# Citizens Coordinating Committee on Friendship Heights

Re: Westbard Self Storage Preliminary Plan No. 12017020280 and Site Plan No. 820170110  
Planning Board Agenda for December 14, 2017 item # 6

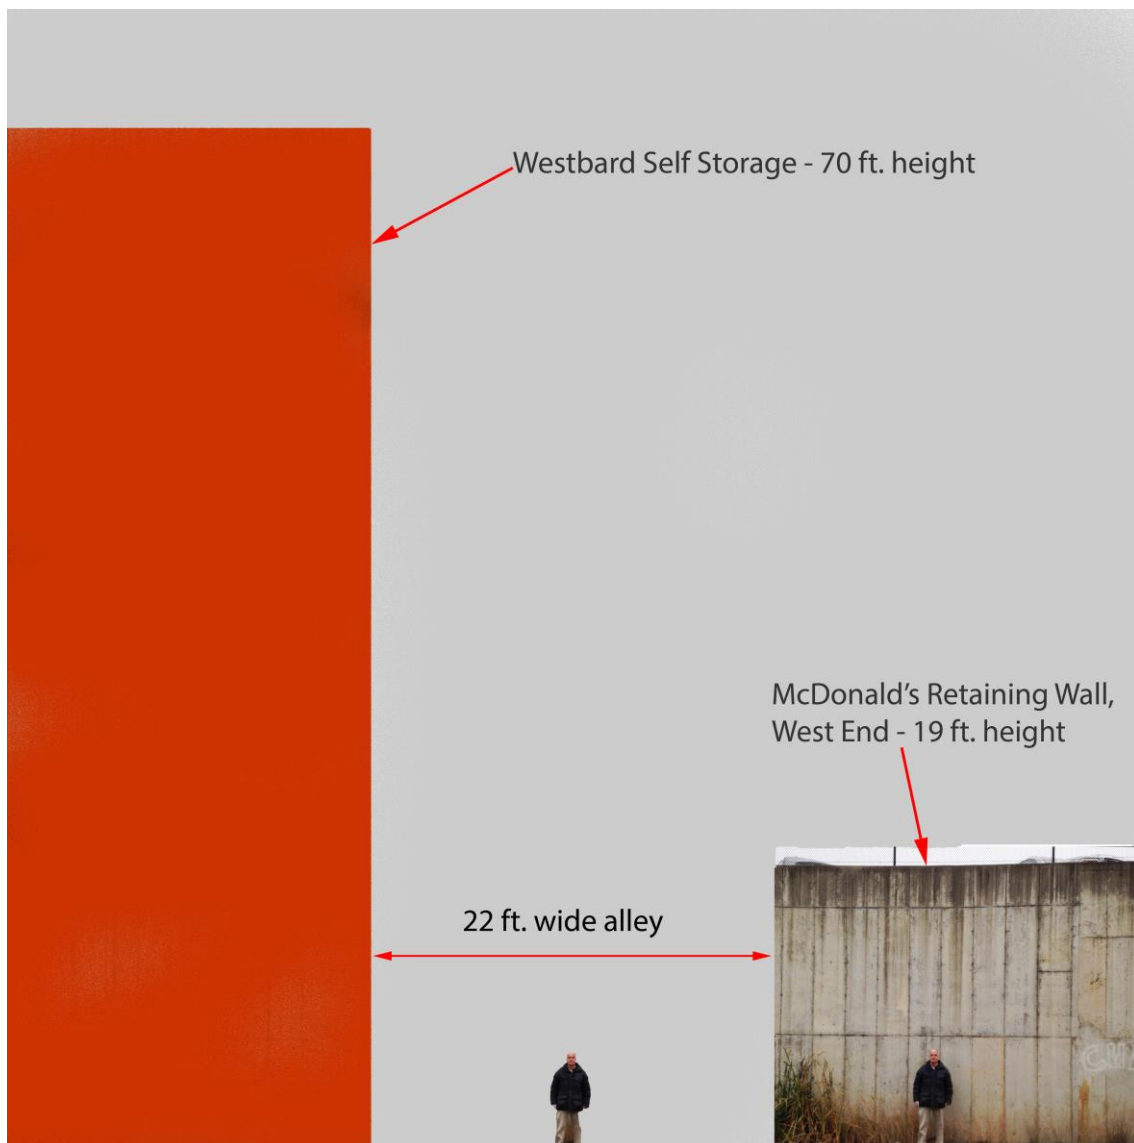
The staff report concludes that the project will provide part of a recommended safe and inviting pedestrian route across Willett Branch for people who want to walk from Westbard Ave. to River Road (p. 38). We strongly disagree. It is anything but inviting and even with lighting will not be viewed as safe. A 195' long alley in an industrial sector with high walls on both sides is a setting that provides a sense of apprehension and entrapment.

Westbard Sector Plan connectivity objective: The Sector Plan contemplated connectivity from the Capital Crescent Trail near River Road, to the Willett Branch, to the major local shopping center on the other side of Westbard Ave (see Sector Plan p. 70 Site 1 & the purple arrow to the east in the Westbard Sector Plan p. 52, reproduced above). In the staff report this very important connectivity path is called Outlet Road or the Outlet Road shared-use path.

This connectivity would be provided in part by an improved and rebuilt path behind commercial properties facing on River Road (see Staff Report pp. 4, 17). There is now a hardscrabble pathway there that is used infrequently by pedestrians and cyclists to travel between River Road and Westbard Ave. (see staff report p. 22). The Outlet Road path is sandwiched between the McDonald's property and proposed storage building.

1. The path should be a minimum of 22'8" wide. That is the width in the sections in the staff report, pp. 23 and 24.
2. The 22'8" should be measured from the building to the further of (1) the property line or (2) the extent of permanent easements for the pathway on the property occupied by McDonald's. In other words, if the Applicant works out easements, its building may be 14'8" feet from the property line. If not, its building is 22'8" from the property line.
3. The upper floors shall not extent over the first above ground floor.
